project	job number	drawn	scale	date created
Clarendon Road Phase 3a	19-028	KHH	1 : 250@A2	Mar' 23

drawing title	drawing number	revision	suitability
Ground Floor Level - Building D4 W257-PTE-D4-00-DR-A-02-0051 Commercial change		P2

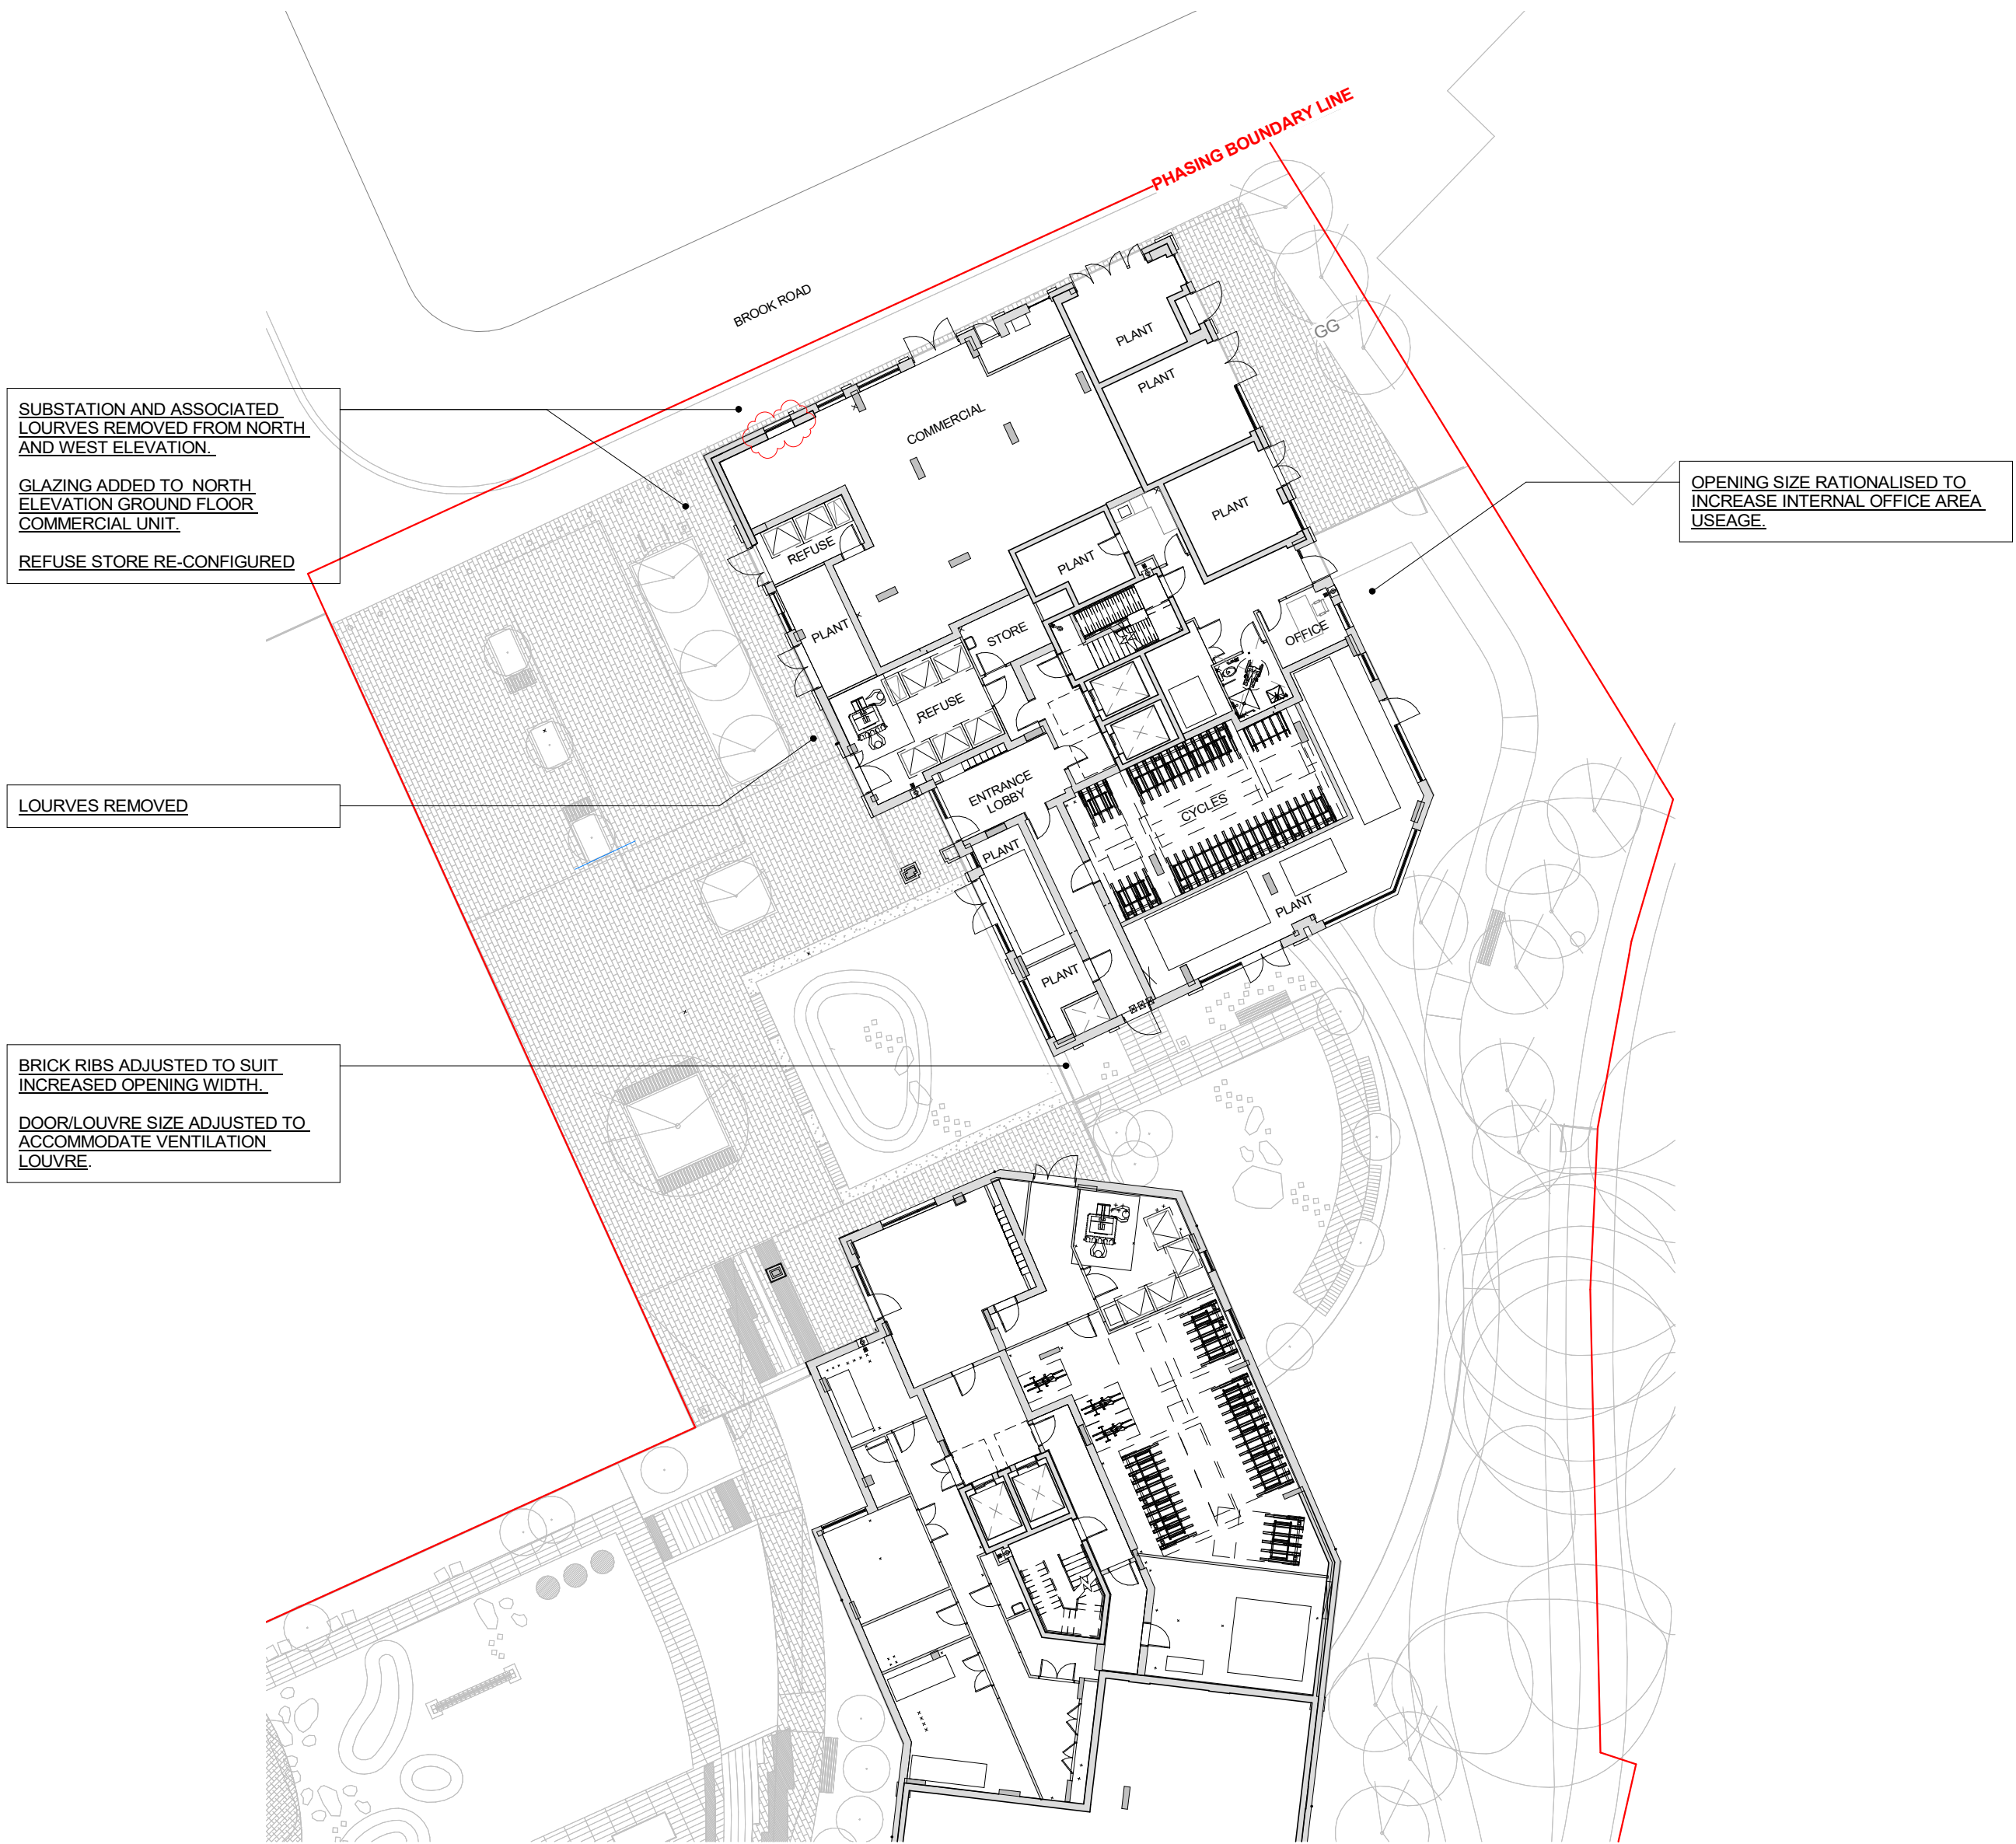
P2	27.03.2023	Issued for planning revision. Minor updates as clouded.	KN	KN
P1	24.03.2023	Issued for planning revision as per client request. Substation and associated louvres removed, commercial floor area increased, commercial glazing added to north elevation, external openings to east and south elevations revised as clouded.	KN	RP
